ADDENDUM NO. 2

WASTEWATER TREATMENT PLANT EXPANSION  
KYLE, TEXAS

CONTRACT DOCUMENTS, DRAWINGS AND TECHNICAL SPECIFICATIONS

P:\PR55768\Cadd\Sheets\18 SITE GRADING PLAN PH2.dwg 10/25/2019 11:07:05 AM Doss, Colleen

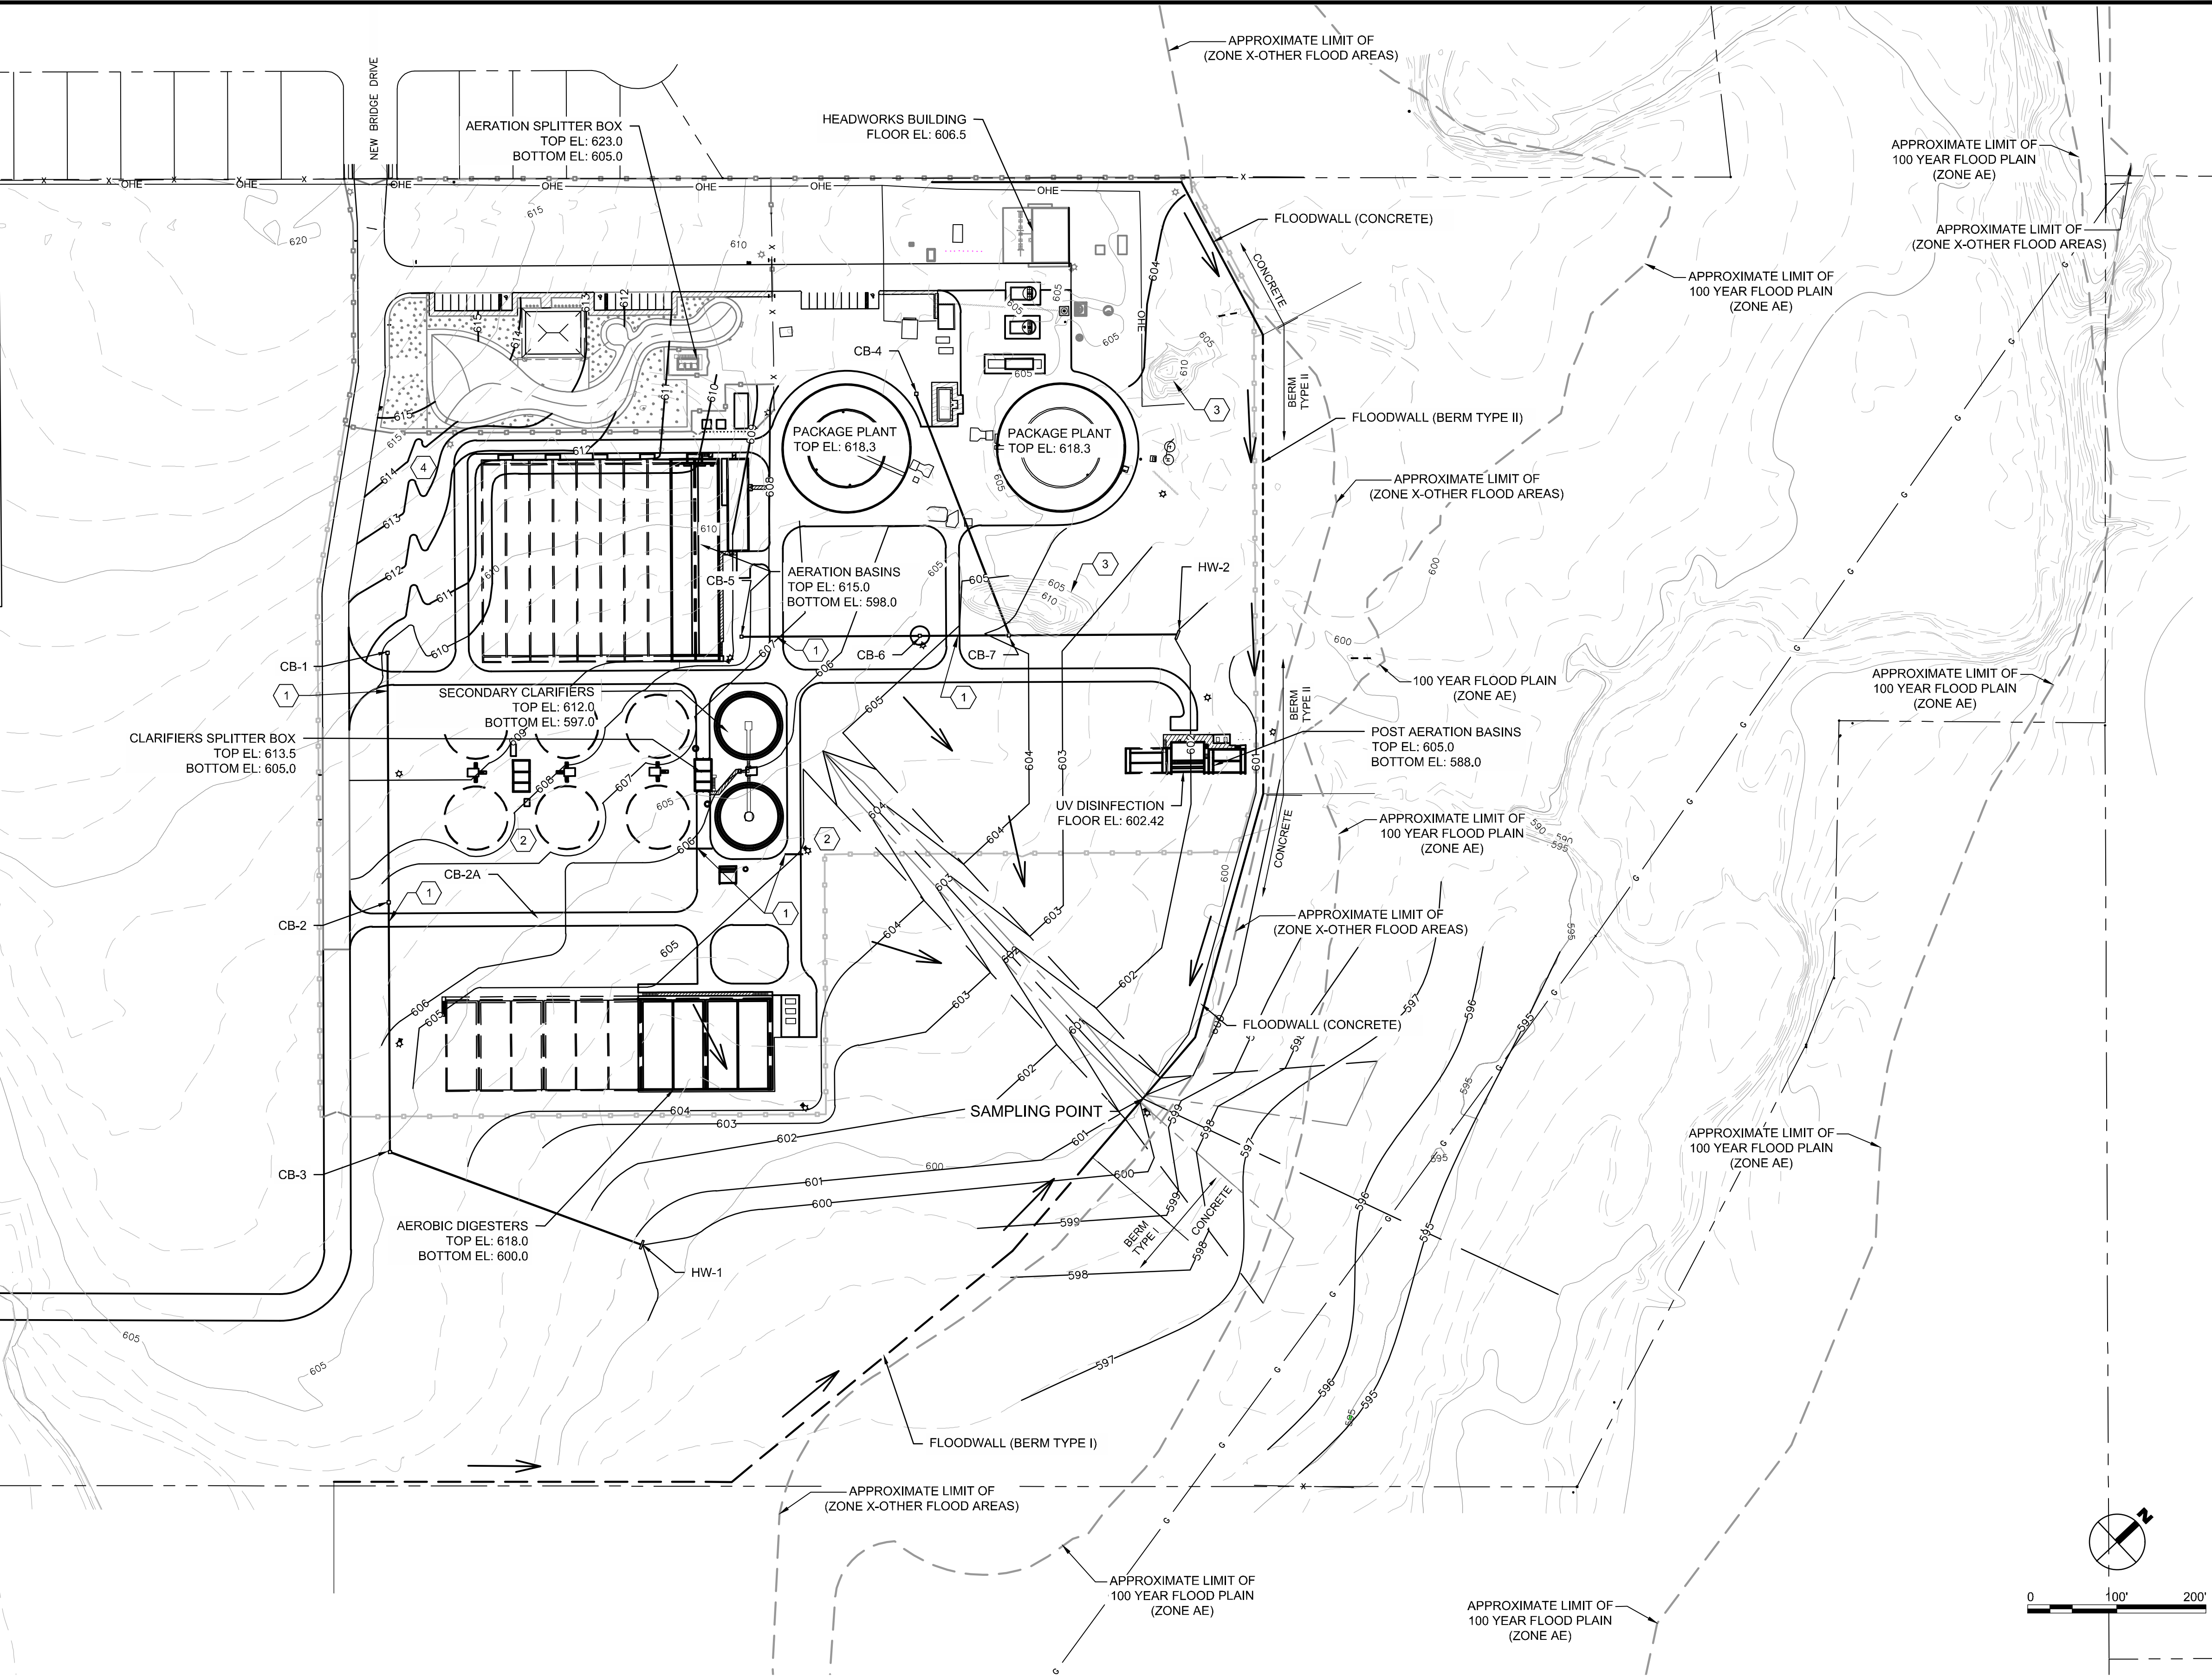
- Answer:**            Delete CB-2A from the project.
- 153      **Question:**      Looking at drawing - 18, we see the callouts for the floodwall berm type - I on the south side of the sampling point and berm type - II, farther north, in line with the existing package treatment plants. Then north of this berm type - II we see the callout for the floodwall (concrete). There is a second floodwall (concrete) shown just north of the sampling point. Does the concrete flood wall extend the whole distance from the south side of the site, around and up to the north side of the site? Does the berm extend along with the concrete wall or just in certain locations? The plan does not clearly show where they are to be installed. Please review and clarify the flood wall berm and concrete wall.

- Answer:**            Limits of concrete, Type I, and Type II walls and berms have been added to revised Sheet 18, issued as part of this addendum.
- 154      **Question:**      Drawing - 113 is showing section views of the earth berms type - I and II. The sections are indicating 6" drain pipe to be placed in the berms. The callout does not indicate what type of drain pipe to provide. We looked through the earthwork specifications and the other piping sections but did not find any mention of this drain pipe. Is the pipe SDR 35, schedule 40 DWV or black flexible corrugated HPDE drain pipe by ADS? Please review and clarify the drain pipe in the earth - flood berms.

P:\PR55768\68\Cadd\Sheets\21 YARD PIPING KEY PLAN PH2.dwg 11/6/2019 10:15:52 AM Doss, Colleen

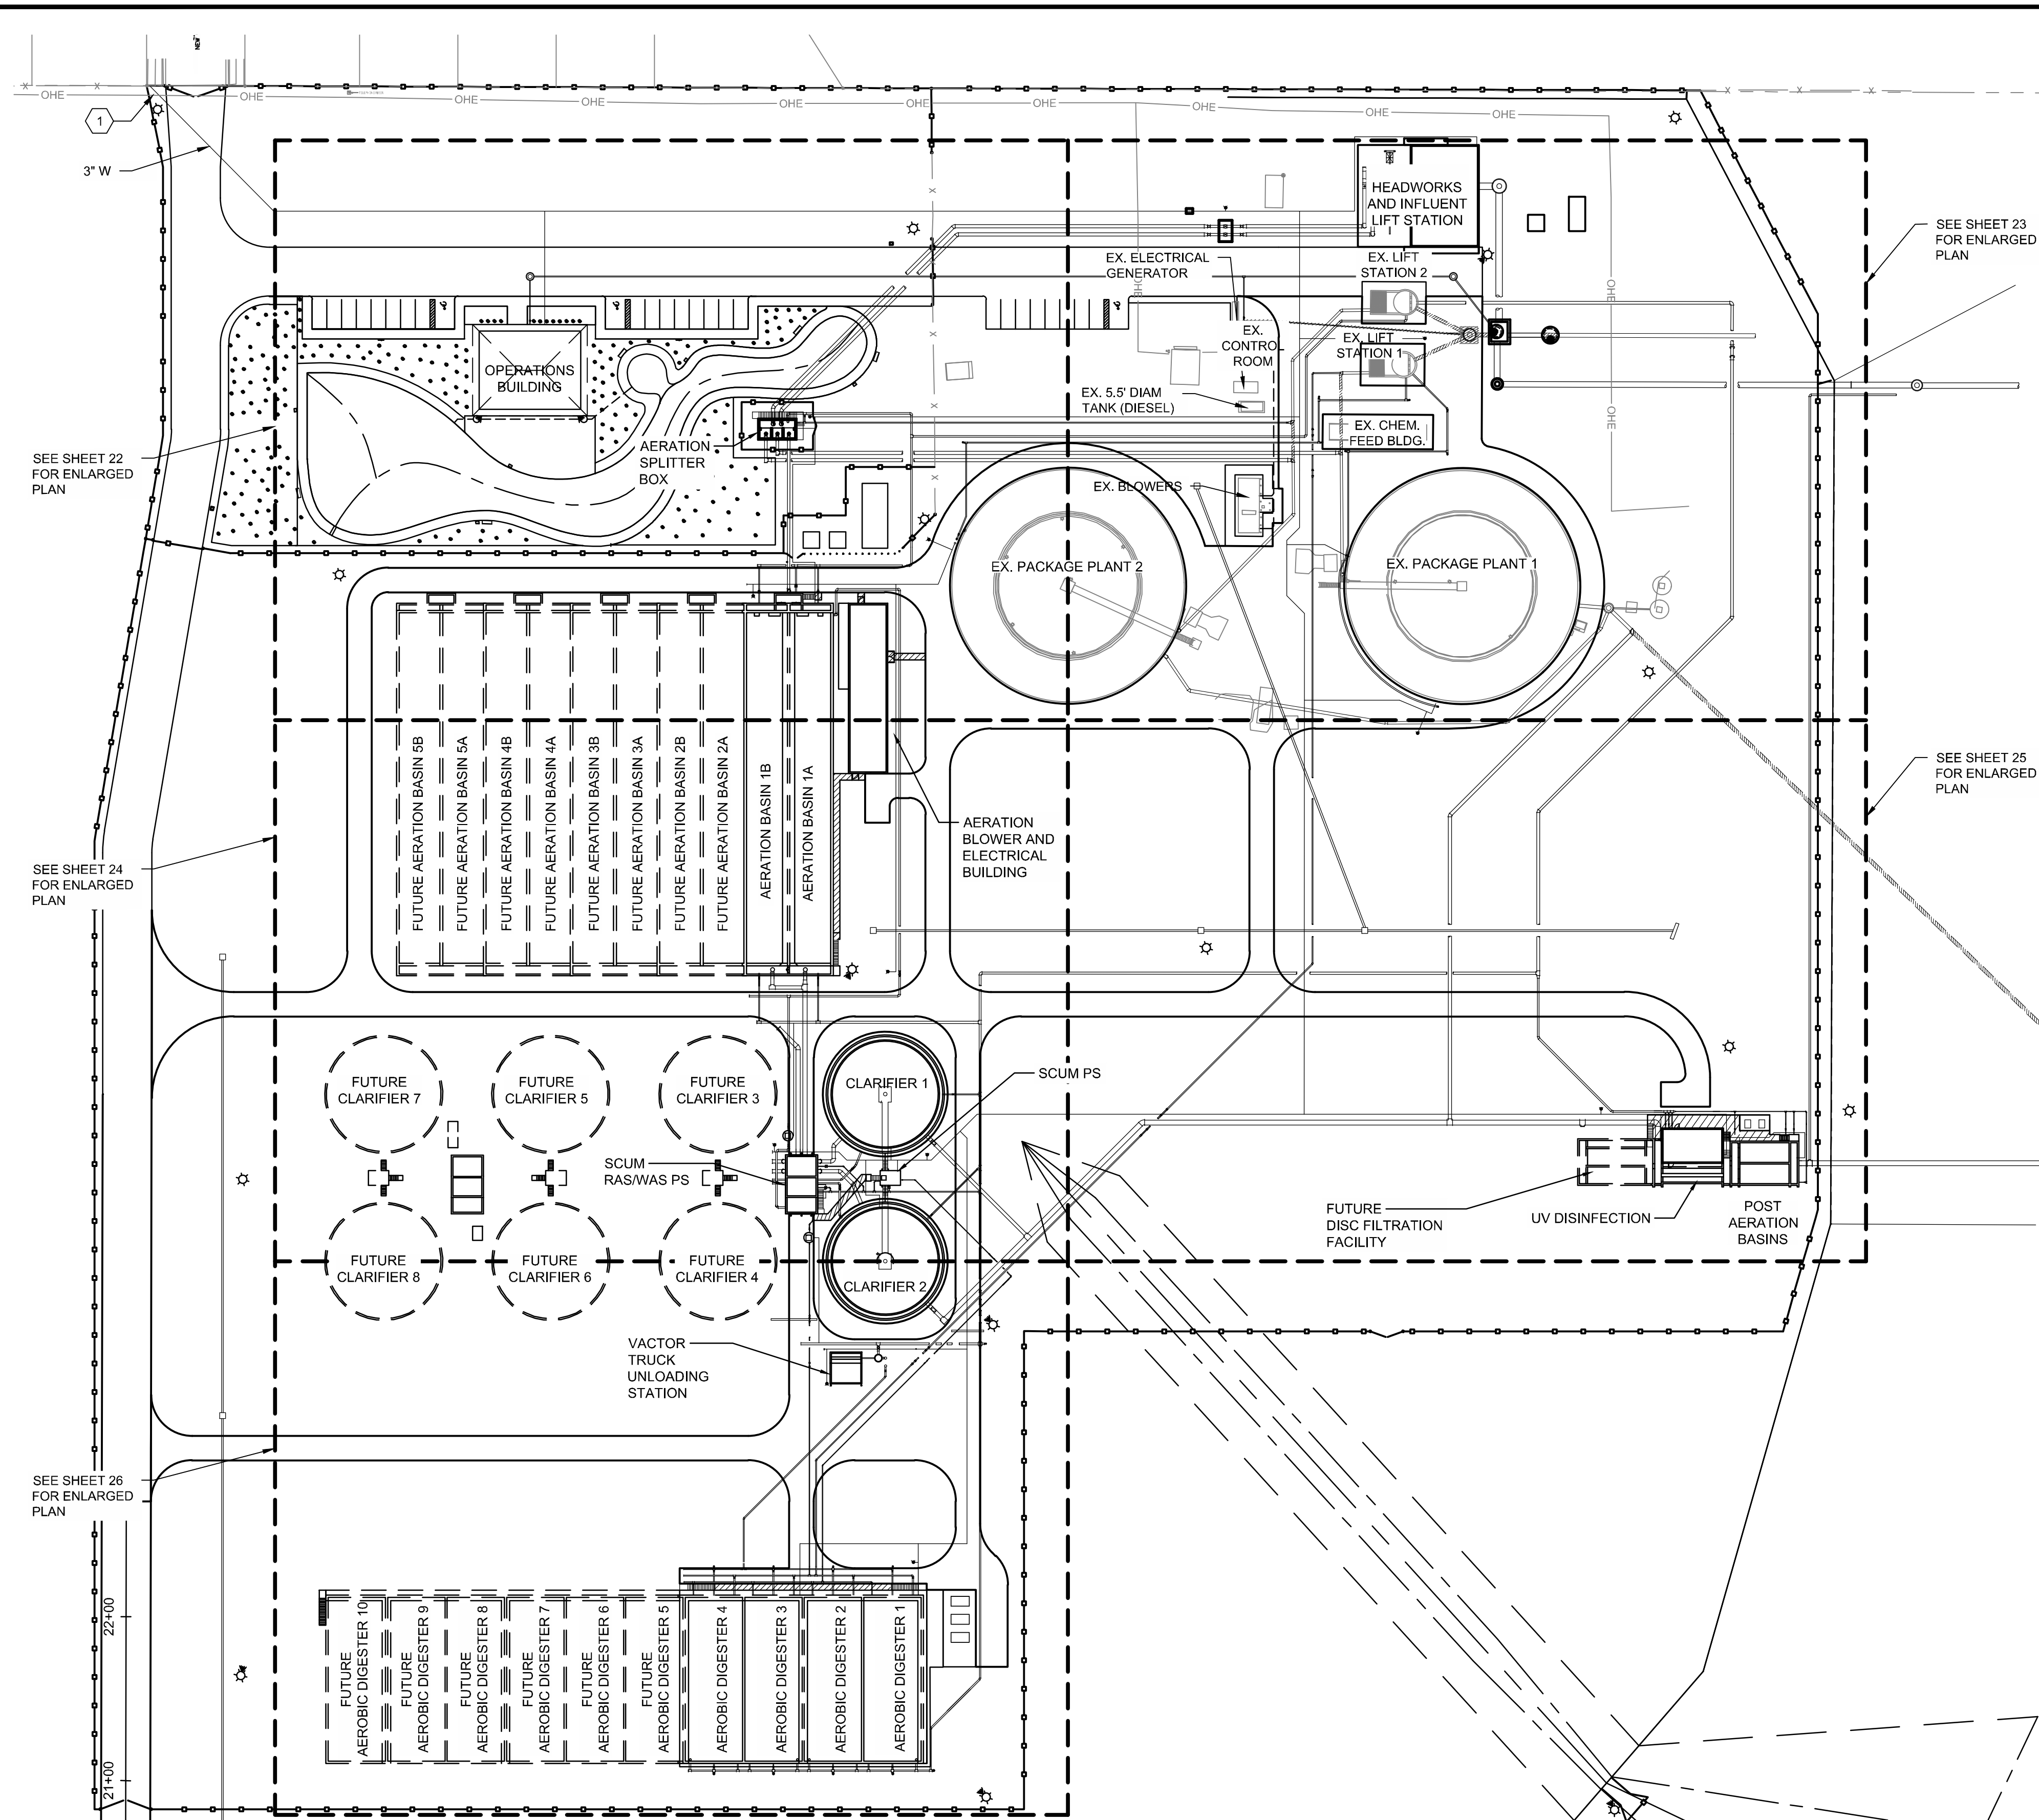
- Answer:**         Revise diameter reference to 1-3/4" (matching the diameter of nonsubmerged service bolts referenced in 2.2.A.3.a).
- 20      **Question:**      We do not see the SW pipe listed in the buried yard piping schedule on drawing 21. Please review and clarify.

- 135      **Question:**      Drawings - 22 and 23 are showing the 8" SS pipe extending from the manhole north of the Operations Building, east to the Influent Junction Box. Looking in the buried yard pipe schedule we do not find a listing for SS service pipe. We see in the specifications sections describing SDR 35 PVC sewer pipe and also a section for ductile iron sewer pipe. Please review and clarify which pipe material is to be provided for the SS line.

- Answer:**            Provide Schedule 80 PVC for all potable water pipes and fittings (W) shown as yard piping on Sheets 21 and 22.
- 138      **Question:**      Reading in the pipe schedule on drawing - 21, we see the listing for NPW, Non-Potable Water line, and the pipe material to be PVC / C900 / DR14. Looking in the project specifications, we do not find a section describing this pipe material and fittings to be provided. The pipe schedule indicates that the pipe shall be restrained sixty feet from a fitting. Please review and clarify this pipe materials and type of restraints to be provided.

- Answer:**         Information for SW piping, which includes flanged above-grade at Influent Lift Station (ISL) and buried pipe to Aeration Splitter Box (ASB), and buried from ASB to two existing package plants (PP) **has been updated on revised Sheet 21, issued as part of this addendum.**

- Answer:**            This pipe is now referenced as OSS and updated in revised Sheet 21, issued as part of this addendum.
- 136      **Question:**      Neither the specs or drawings provide the type of fiber (single mode or multimode). Please advise.

- Answer:**            Provide Schedule 80 PVC for all NPW pipes and fittings shown on yard piping sheets. Bell or screwed ends are acceptable, with fittings restrained accordingly for operating and test pressure requirements. See schedule on revised Sheet 21, issued as part of this addendum.
